Landscape Review Committee

DATE: April 20, 2022
TO: Landscape Review Committee Members
FROM: Monica Bilodeau, Senior Planner
SUBJECT: Landscape Plan Review Application (L 31-21)

This proceeding is a review of the Oak Ridge Meadows Subdivision landscape plan and private park plan (L 31-21). Staff has reviewed the application for consistency with the applicable criteria, and recommends approval of the application, subject to the conditions specified in the attached Decision Document.

DOCKET: L 31-21 (Landscape Plan Review)

L2.1
SHEET 6 OF 8

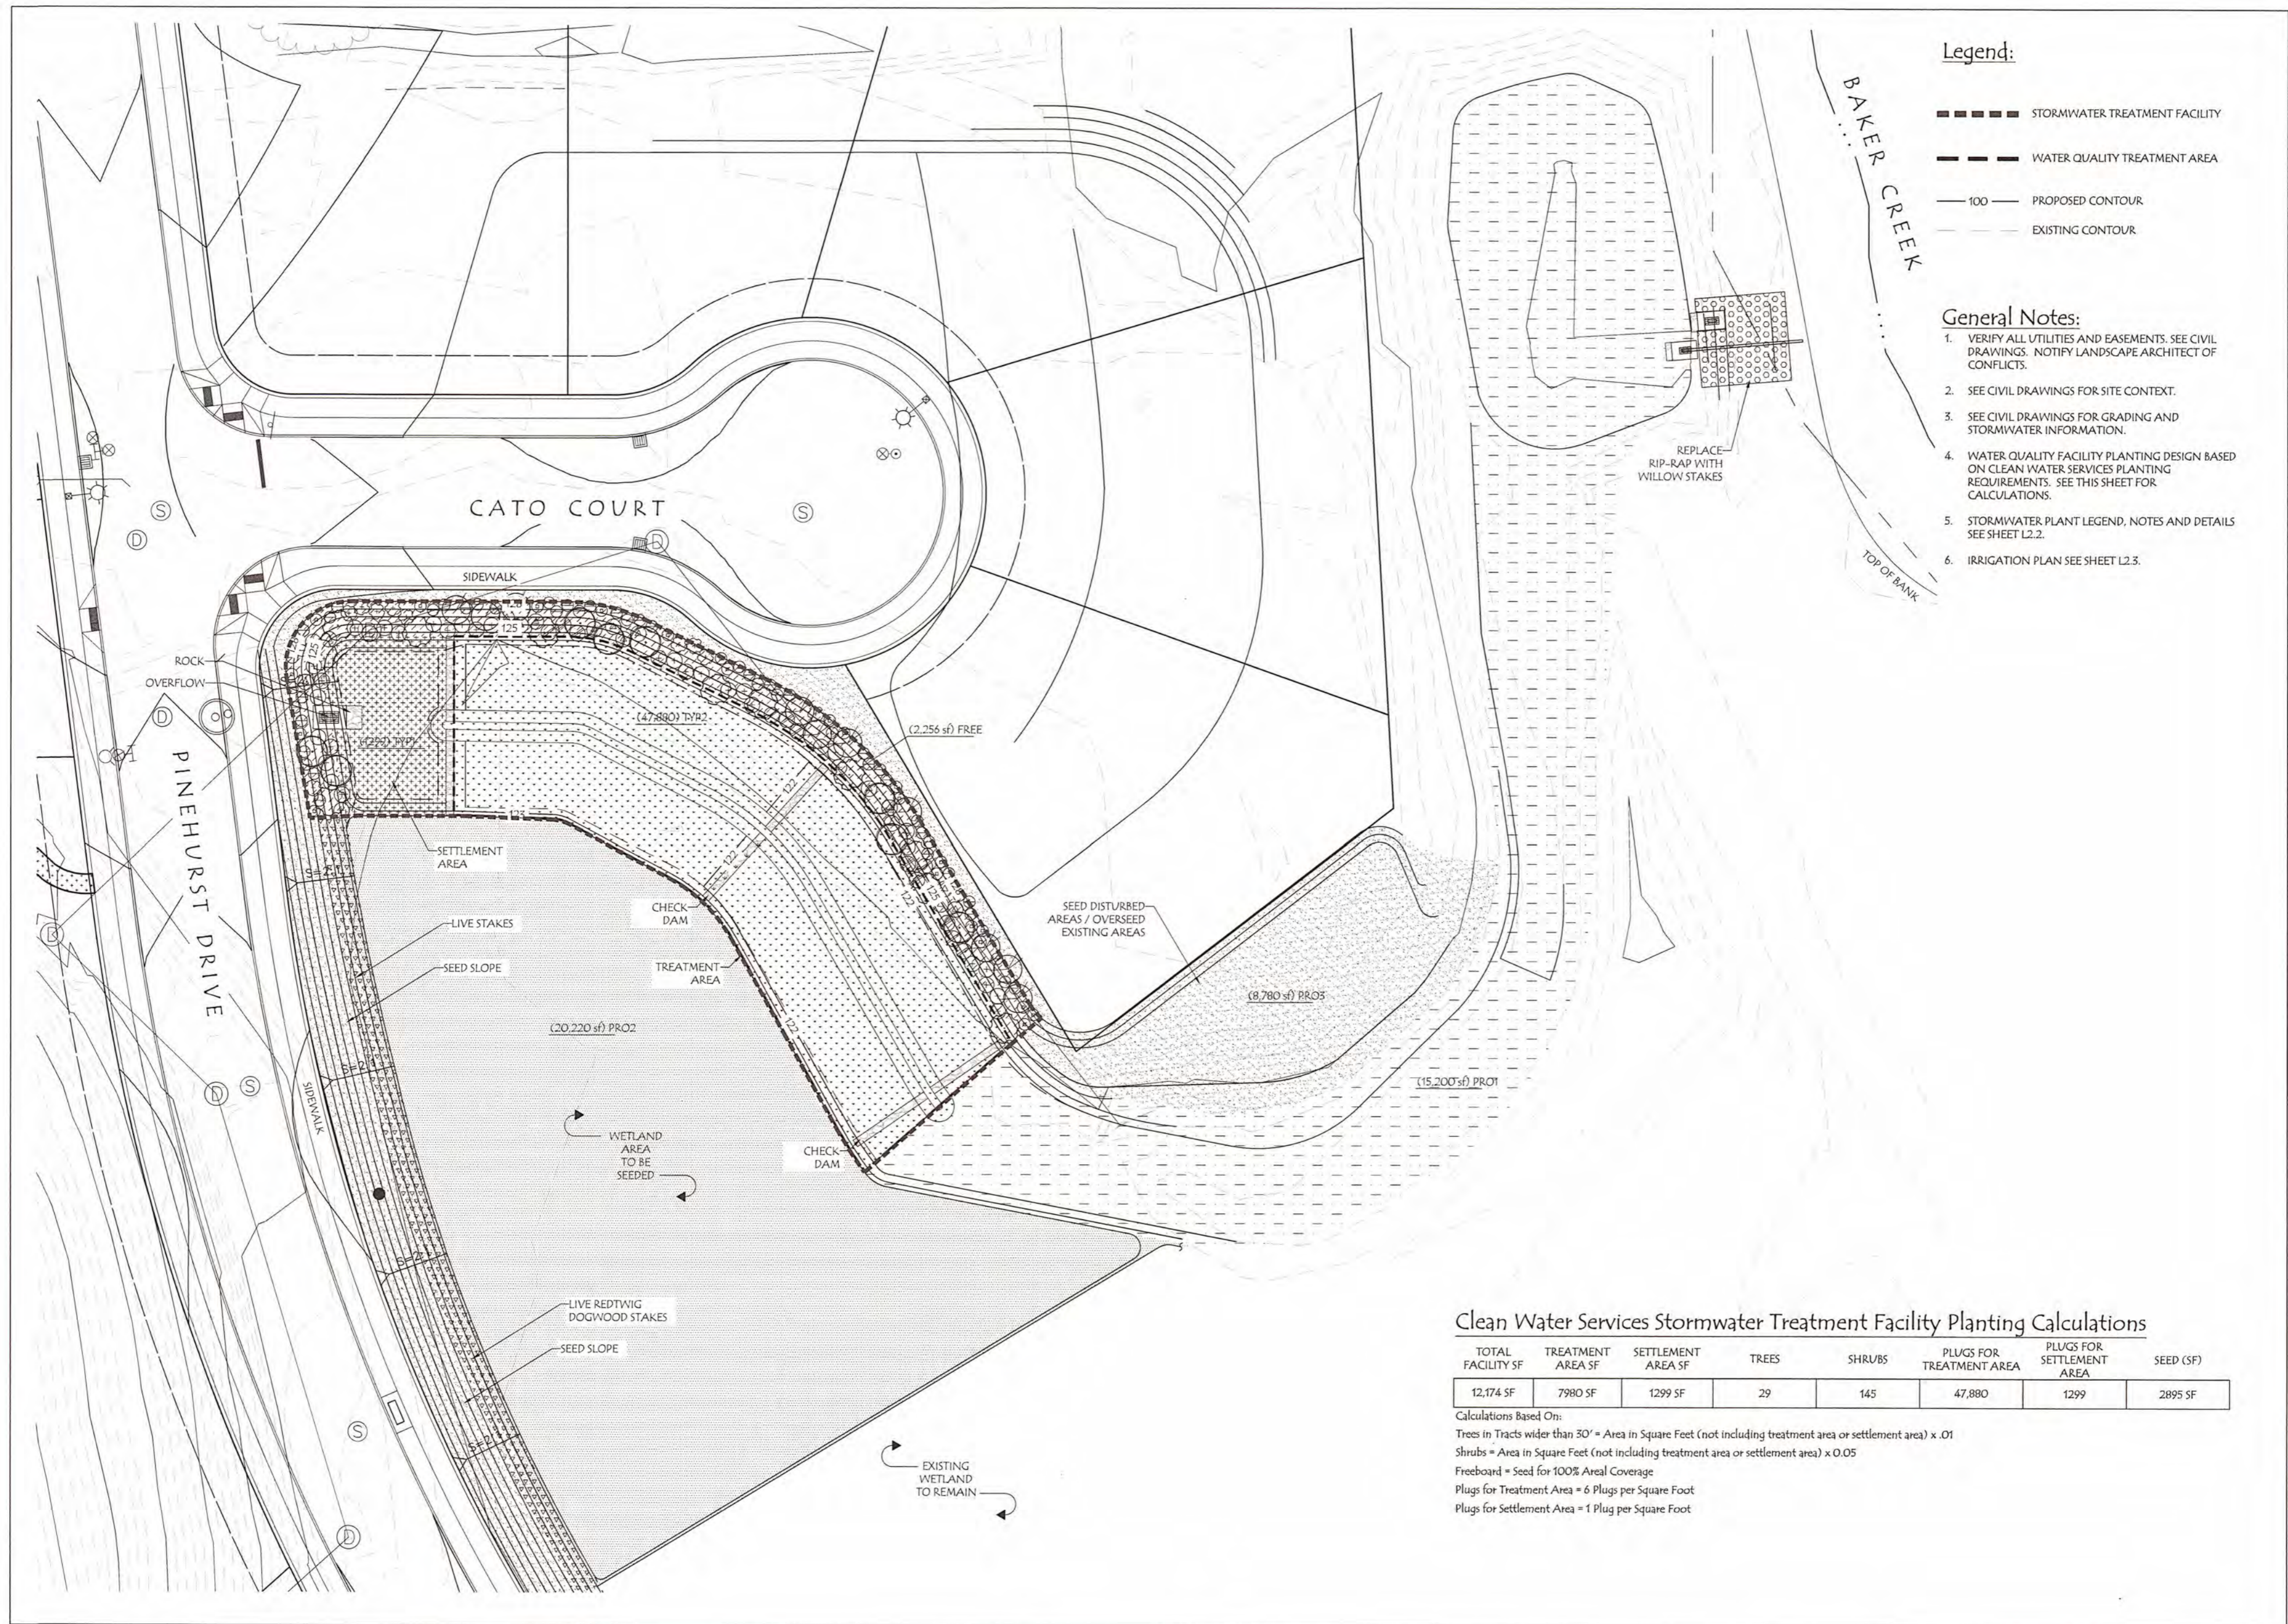
4. The City does not have adopted Stormwater facility planting requirements. The planting scheme appears to be similar to Clean Water Services standards for material and spacing.
5. As a note, the HOA will be responsible for maintaining the plant material in the storm water facility.
